INDESIT company

MBM1722VFR

F043309

51820b0 Exploded views

N1030093fig1

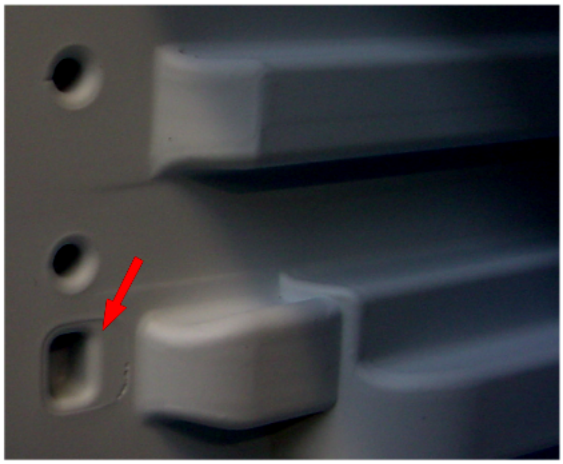
n1030093: New fixing of evaporator on static fridge-freezers (05 range) 60 cm,Melano

From August 05 (serial no. 50802.0001) the freezer evaporator is secured to the cabinet by a plastic profile.
The cabinet walls have been modified to create locations to house the profile, which is installed on the front of each evaporator plate (see photo N1030093fig1- fig2 - fig3)
The profile cannot be fitted on premodification appliances, so technical personnel must continue to fit the rh and lh supports on these models (see photo N1030093fig4)

New parts
C00141135 = WHITE PROFILE L=443.5 MM

Parts replaced
C00075596 = EVAPORATOR RH SUPPORT
C00075597 = EVAPORATOR LH SUPPORT
